HISTORIC AND DESIGN REVIEW COMMISSION

October 20, 2021

HDRC CASE NO: 2021-471
ADDRESS: 222 W WOODLAWN AVE
LEGAL DESCRIPTION: NCB 1859 BLK 2 LOT 6 & E 35 FT OF 5
ZONING: R-4, H
CITY COUNCIL DIST.: 1
DISTRICT: Monte Vista Historic District
APPLICANT: Christopher Gelabert/GELABERT CHRISTOPHER JAMES & CASSANDRA
OWNER: Christopher Gelabert/GELABERT CHRISTOPHER JAMES & CASSANDRA
TYPE OF WORK: Demolition and reconstruction of accessory structure with the construction of a second-story addition
APPLICATION RECEIVED: September 16, 2021
60-DAY REVIEW: Not applicable due to City Council Emergency Orders
CASE MANAGER: Rachel Rettaliata
REQUEST:

The applicant is requesting conceptual approval to:

PROPOSED DESIGN

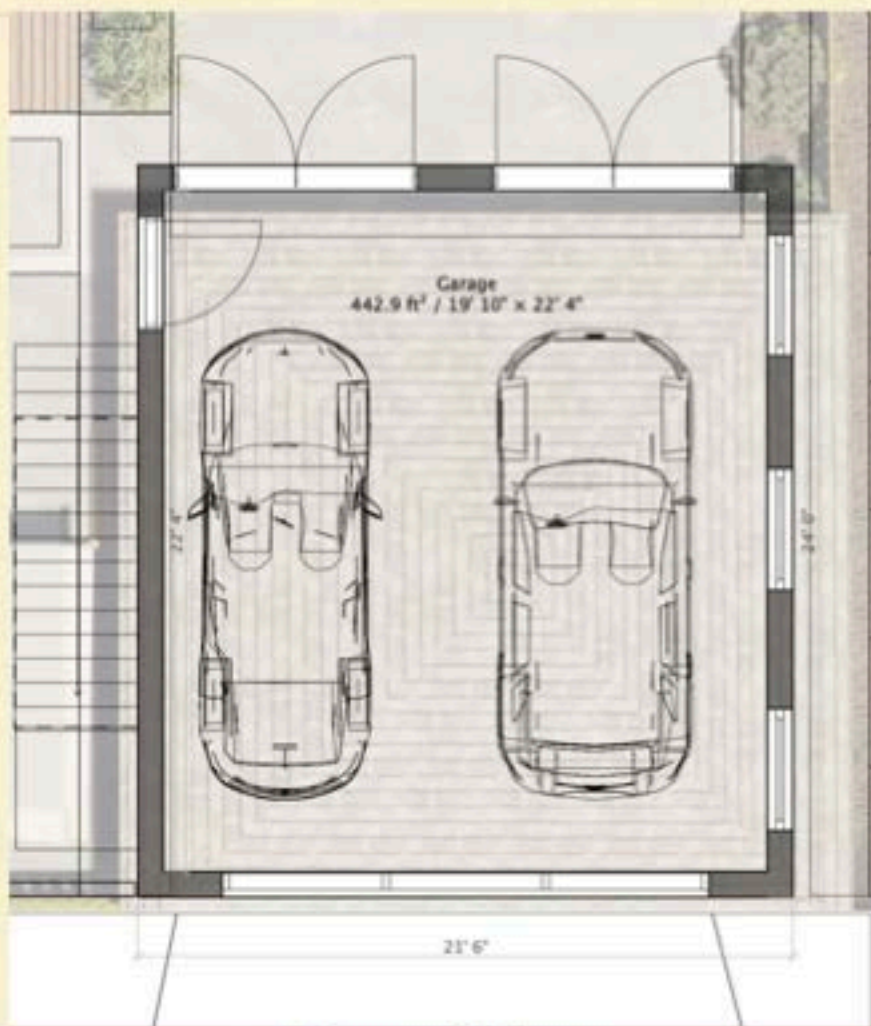
- 2e. **MATERIALS** – The applicant has proposed to reconstruct the garage structure using existing wood lap siding salvaged from the existing garage and new wood lap siding to match the existing garage and the primary structure, a red asphalt shingle roof to match the primary structure, two carriage doors on the north façade, wood windows to match the windows on the primary structure, and an exterior wood staircase. The applicant has proposed to re-use the existing aluminum garage door on the south elevation and the pedestrian door on the west elevation. The existing structure features wood siding that matches the primary structure, a pressed tin roof, wood carriage doors on the north façade, an aluminum garage door on the south elevation, and a pedestrian door on the west elevation. Staff finds the materials appropriate.

- 2f. **MATERIALS: DOORS AND WINDOWS** – The applicant has proposed to install fully wood windows. The fully wood windows should feature an inset of two (2) inches within facades and should feature profiles that are found historically within the immediate vicinity. An alternative window material may be proposed, provided that the window features meeting rails that are no taller than 1.25” and stiles no wider than 2.25”. White manufacturer’s color is not allowed, and color selection must be presented to staff. There should be a minimum of two inches in depth between the front face of the window trim and the front face of the top window sash. This must be accomplished by recessing the window sufficiently within the opening or with the installation of additional window trim to add thickness. Window trim must feature traditional dimensions and an architecturally appropriate sill detail. Window track components must be painted to match the window trim or be concealed by a wood window screen set within the opening. The applicant has not provided material specifications for the proposed pedestrian door. Fully wood carriage and pedestrian doors would be most appropriate.

- 2g. **RELATIONSHIP OF SOLIDS TO VOIDS** – Guideline 2.C.i for New Construction stipulates that new construction should incorporate window and door openings with a similar proportion of wall to window space as typical with nearby historic facades. Windows, doors, porches, entryways, dormers, bays, and pediments shall be considered similar if they are no larger than 25% in size and vary no more than 10% in height to width ratio from adjacent historic facades. Guideline 5.A.iv for New Construction states that window and door openings should be designed to be similar to those found on historic garages or outbuildings in the district or on the principle historic structure in terms of their spacing and proportions. The applicant has submitted renderings of the reconstructed rear accessory structure that feature windows with traditional window proportions on the second-story addition, but narrow horizontal fixed windows on the first floor of the east façade. Staff finds that the applicant should proposed a fenestration pattern with traditional proportions.

- ii. That the applicant proposes a fenestration pattern and window opening proportions that are more consistent with the Guidelines and the Standard Specifications for Windows in Additions as noted in finding 2g. The applicant is required to submit updated elevation drawings showing traditional window proportions on the east elevation to staff for review prior to returning to the HDRC for final approval.

- iii. That the applicant submits window specifications for fully wood windows to staff for review. Wood windows are recommended and should feature an inset of two (2) inches within facades and should feature profiles that are found historically within the immediate vicinity. Meeting rails must be no taller than 1.25" and stiles no wider than 2.25". White manufacturer's color is not allowed, and color selection must be presented to staff. There should be a minimum of two inches in depth between the front face of the window trim and the front face of the top window sash. This must be accomplished by recessing the window sufficiently within the opening or with the installation of additional window trim to add thickness. Window trim must feature traditional dimensions and architecturally appropriate sill detail. Window track components must be painted to match the window trim or concealed by a wood window screen set within the opening.

Ground Floor

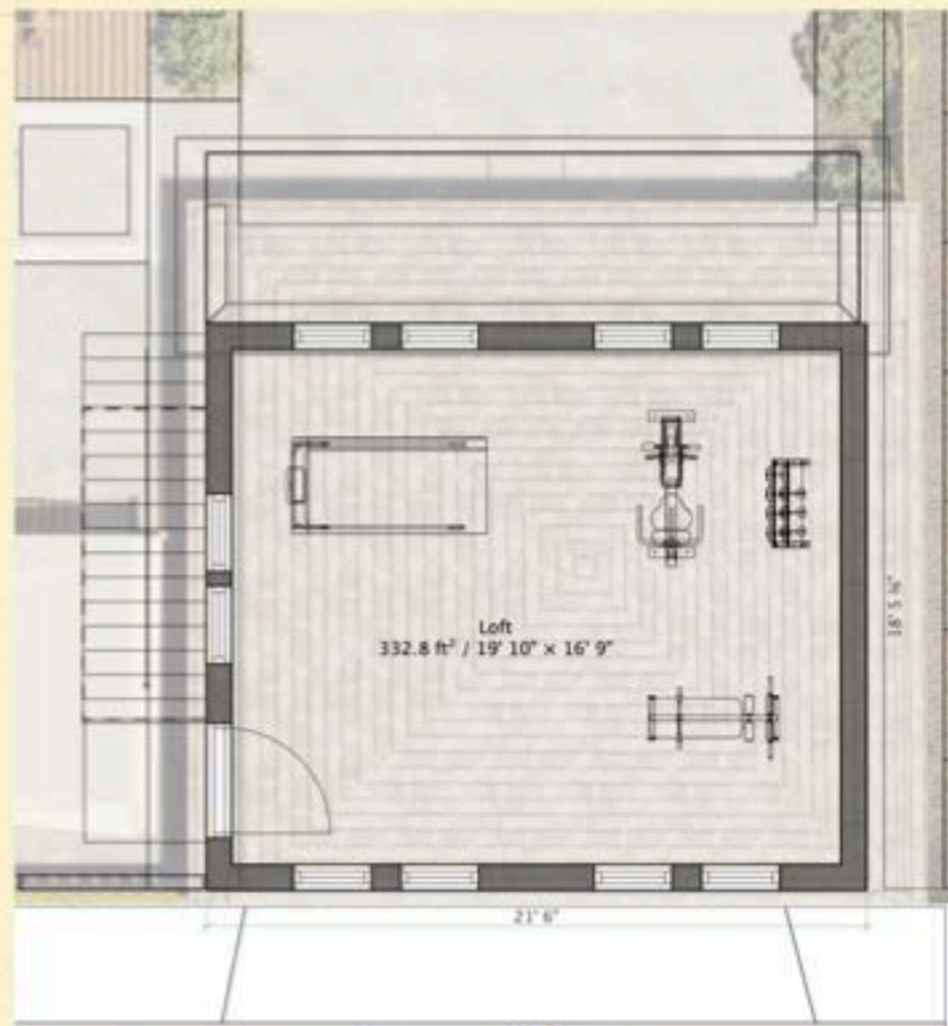
- 2c. **FOOTPRINT** – The applicant has proposed a footprint of approximately 443 square feet for the garage structure and approximately 332 square feet for the second-story addition. According to the Historic Design Guidelines, new construction should be consistent with adjacent historic buildings in terms of the building to lot ratio. Additionally, Guideline 2.D.i for New Construction states that the building footprint for new construction should be limited to no more than 50 percent of the total lot area. The proposed garage reconstruction will match the footprint of the existing garage structure with a difference of 30 inches. Staff finds the proposal appropriate.
